2700 ELLIOTT AVENUE  
**JOSEPH ARNOLD LOFTS**  
DESIGN REVIEW RECOMMENDATION MEETING #2

DPD NO.3009932

JUNE 28, 2011

### INITIAL RECOMMENDATION OF THE DOWNTOWN DESIGN REVIEW BOARD

Balconies, Decks and Railings

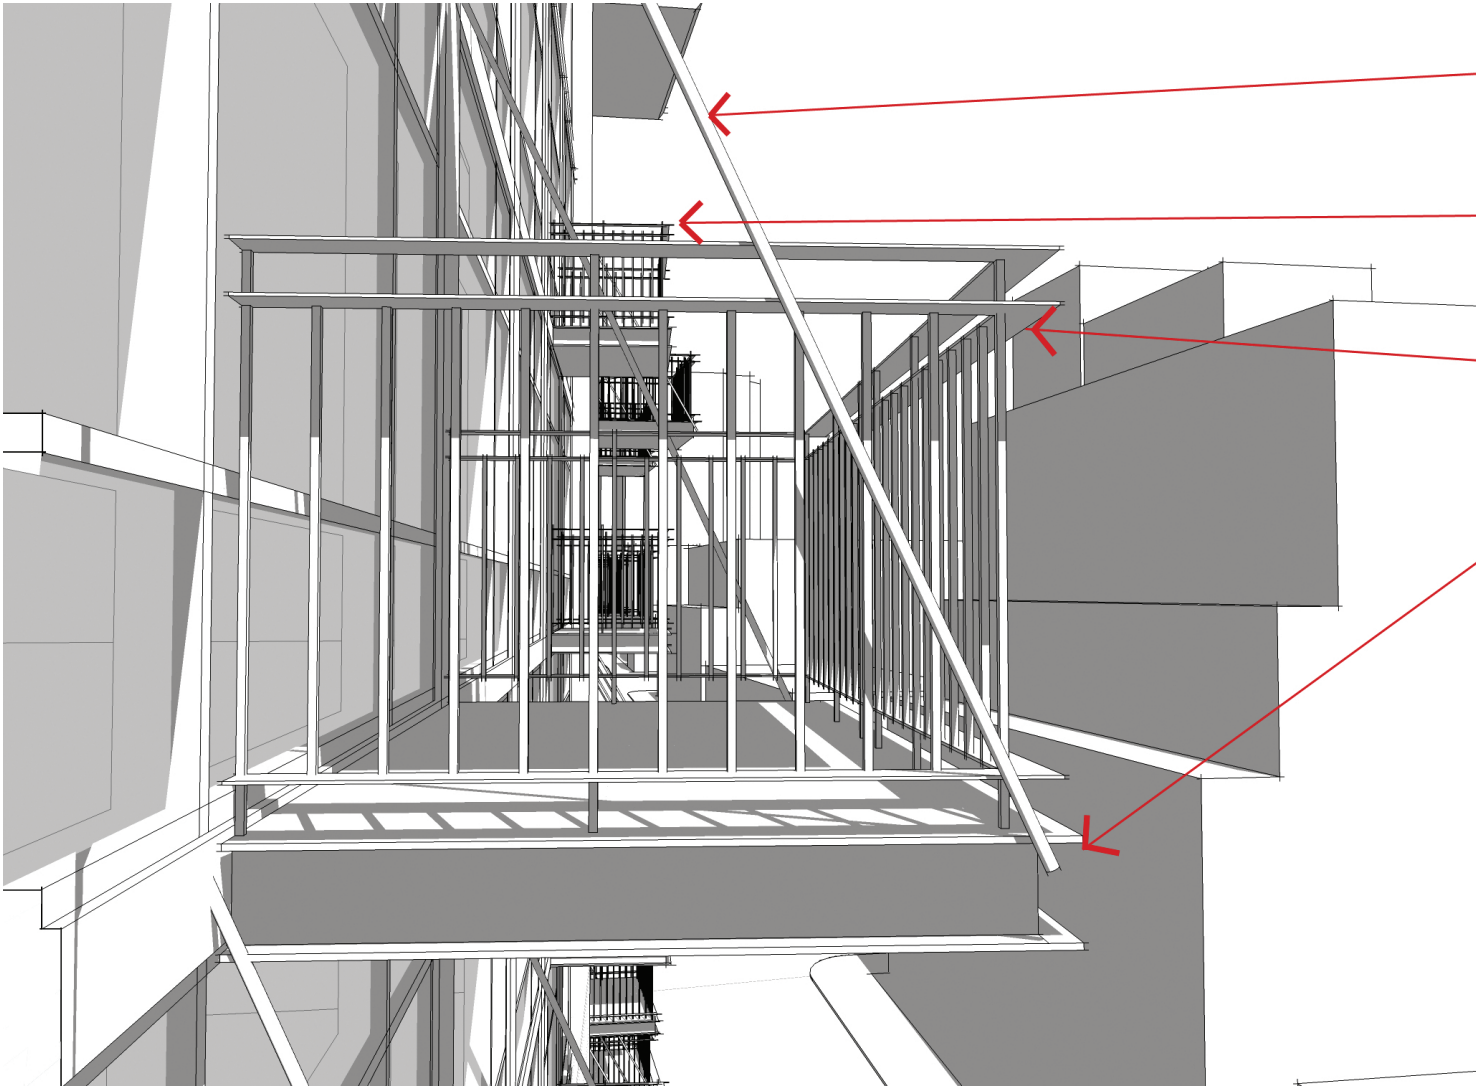
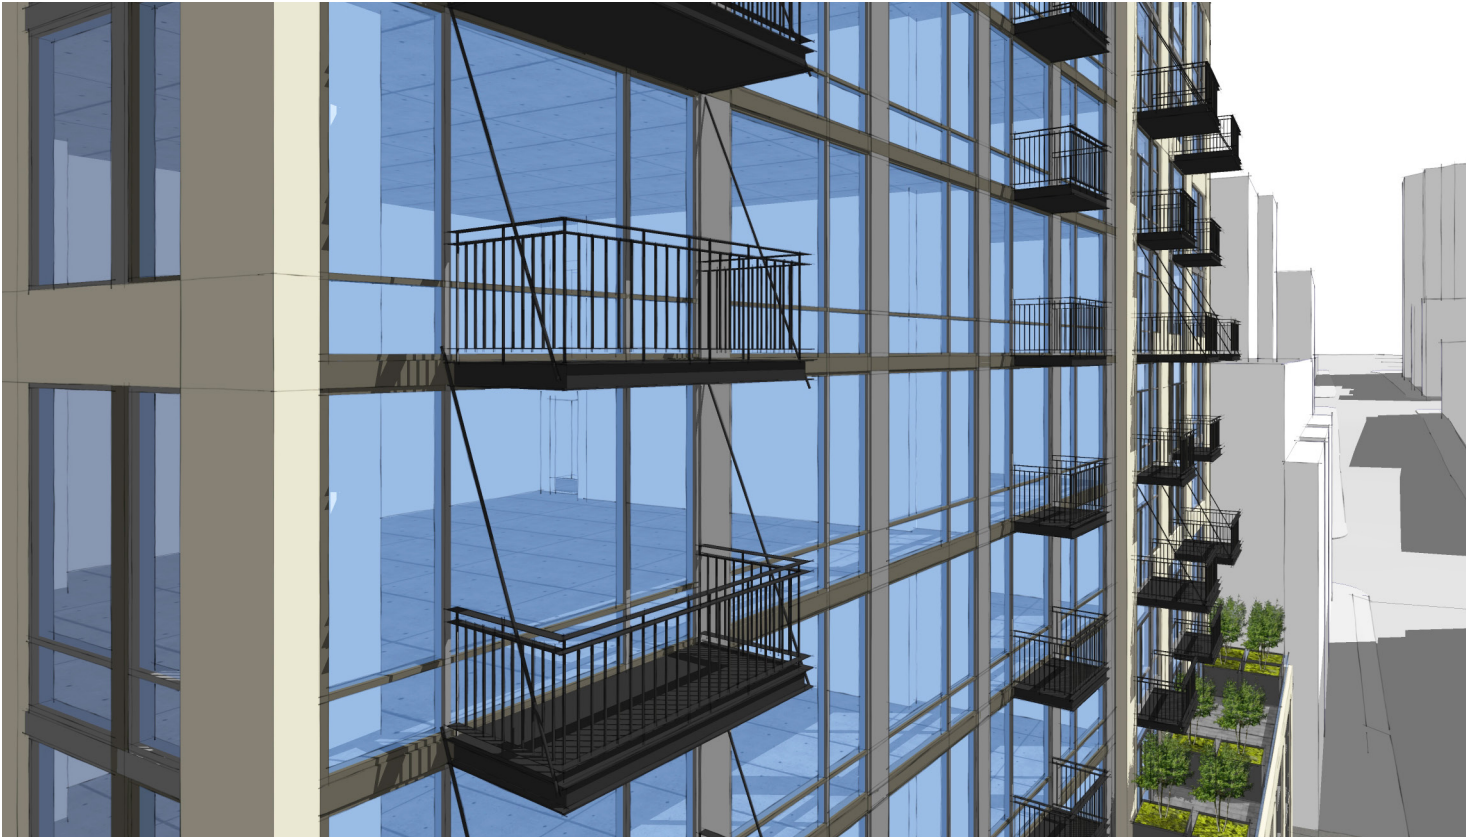
The Board stated they want to see detailing of the railings and of the “eyebrow” overhang elements at the next meeting. Concern was expressed that the features might fail to convey substance and quality and be a positive addition to the building if they were not properly designed and executed.

The design language proposed for the decks and railings is understandably industrial, metallic and “loft-like”. These iron balconies will be painted black, and represent the “third level” of detail from the precast concrete frame and the dark-anodized window-wall system and panels. The street-level marquees participate at this detail level as well, providing texture, a finer grain and human scale to the building.

detail along south elevation -- showing deck, railing and hangers

## Bay Window at Corner of Elliott & Cedar

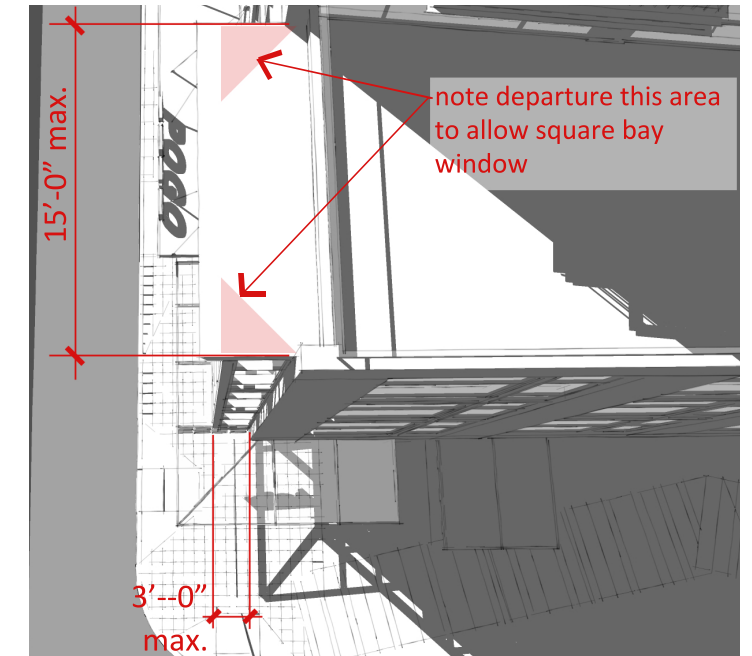
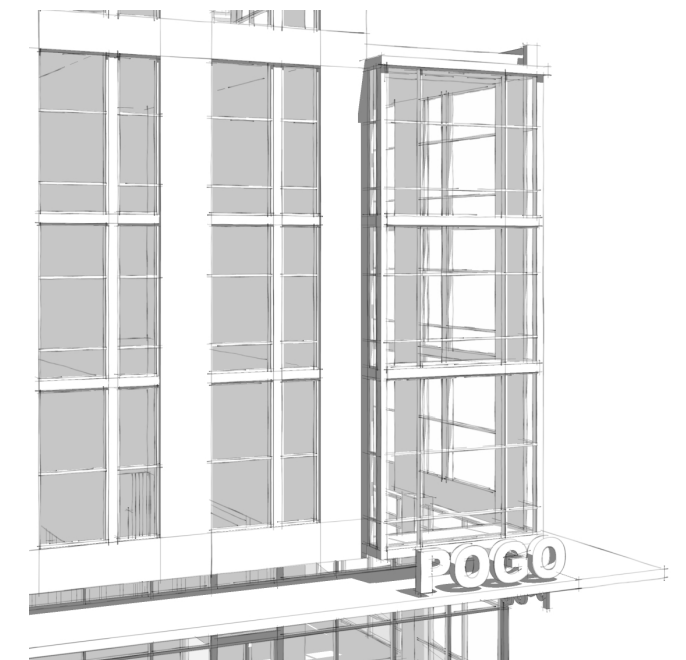
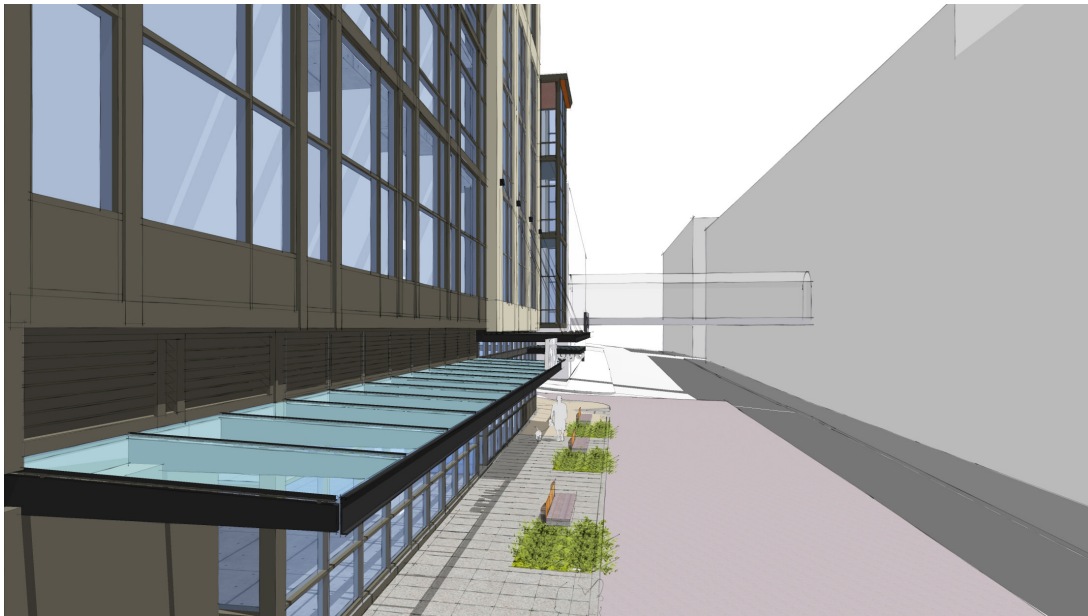
The Board observed that the Cedar St. façade was successful and requested that the Elliott Ave. façade be further designed to reflect and relate better to the one on Cedar St. The Cedar St. façade has a “frame” expressing a base which should be more closely approximated on Elliott Ave. It stated that Cedar St. façade “wants to” wrap around the corner. And while the sharp angularity of the bay window element is OK, it needs to be deeper to be more obvious.

While a 2-foot projecting bay window had been previously proposed in this location, the DRB believed that a 3-foot window, the maximum extent permitted by the Land Use Code, would be preferable. We concur.

A Design Departure is required to permit the window to have square corners, and not be truncated at 45-degree angles as prescribed by code.
